# UNITED STATES PATENT AND TRADEMARK OFFICE

APPLICATION NO.	FILING DATE	FIRST NAMED INVENTOR	ATTORNEY DOCKET NO.	CONFIRMATION NO.
10/684,021	10/10/2003	Kenneth Turos	2067.030	3201
7590	07/27/2005		EXAMINER	
Ray R. Regan LAW OFFICE OF RAY R. REGAN, P.A. P.O. Box 1442 Corrales, NM 87048				ADDISU, SARA
			ART UNIT	PAPER NUMBER
			3722	
DATE MAILED: 07/27/2005

<b>Office Action Summary</b>	<b>Application No.</b>	<b>Applicant(s)</b>	
	10/684,021	TUROS, KENNETH	
Examiner	Art Unit		
Sara Addisu	3722

**DETAILED ACTION**

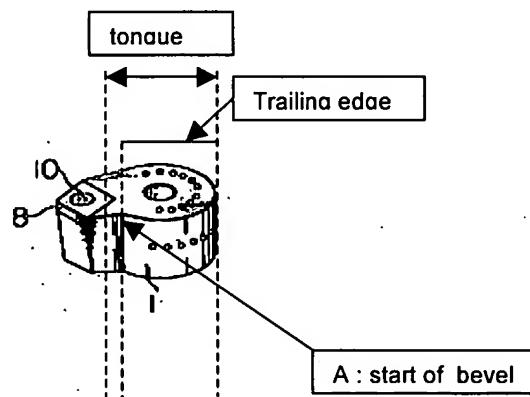
In response to Applicant's assertion on page 14, line 33- page 15, line 6 that Suzuki Patent does not disclose a partially beveled edge formed in the trailing edge of

the tongue for restricting movement of the swivel member, Applicant is referred to the diagram below where the trailing edge of the tongue is indicated. It should be noted that Suzuki teaches a partially beveled edge (starting at A) formed in the trailing edge for restricting movement of the swivel member by engaging ball (26) with one of the recesses (6) located in the beveled section of the trailing edge ('884, Col. 2, lines 49-55). With regards to the "means for locking" recited in claims 1 and 19, the limitation meets the three-prong test per MPEP 2181 and thereby invokes 35 U.S.C. 112, 6<sup>th</sup> paragraph. Suzuki teaches ball (26) being engaged with one of the recesses (6). Ball (26) and recess (6) are capable of performing the identical function "positioning the cutter in relationship to a surface of the workpiece" in substantially the same way (swinging swivel member to a desired position) and produces substantially the same result (indexing cutter/positioning cutter in relation to a workpiece) as a bevel.
